MEMORANDUM

Date: September 26, 2018

Re: Requested design alterations and additional information for the Sugar House Heights
Planned Development and Preliminary Subdivision at 2660 S. Highland Drive / Petition
#PLNSUB2017-01027 & PLNSUB2017-01028

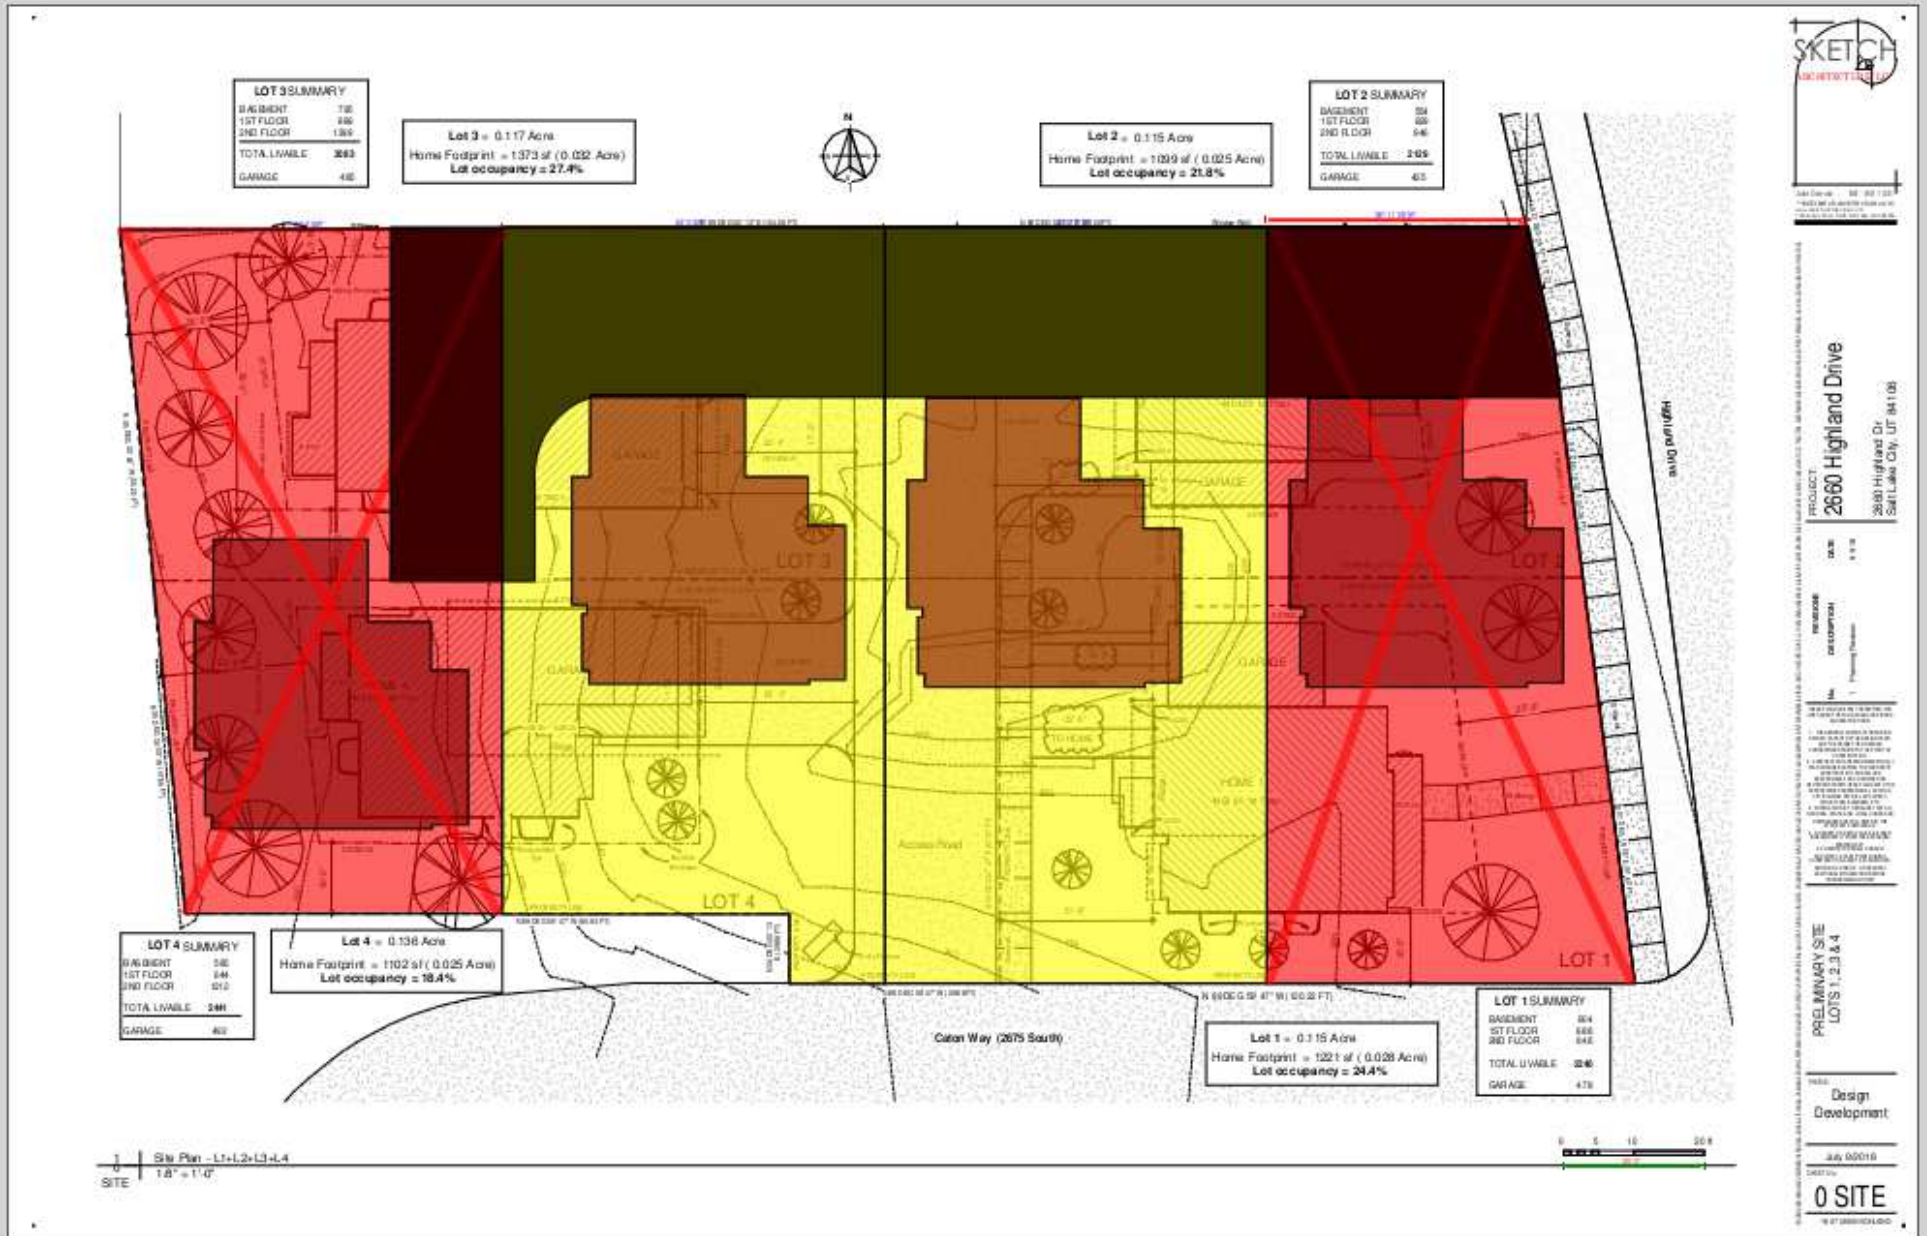
Can you please elaborate on the sketch and what it is showing? It looks like you reconfigured the 4 houses to run in an east to west direction, but how does it show that access off of Highland wouldn't fit?

The Commission will likely bring up how you can request relief from many zoning requirements (namely required setback dimensions), so not being able to meet setbacks wouldn't necessarily be a deal breaker for that layout. More information would be appreciated so I can provide it in my report.

Our position is that we have the right to use the easement. No legal requirement to explore the other option.

Here is our rewritten PUD and attached is a sketch of how we can't get 4 lots with a road from the north.
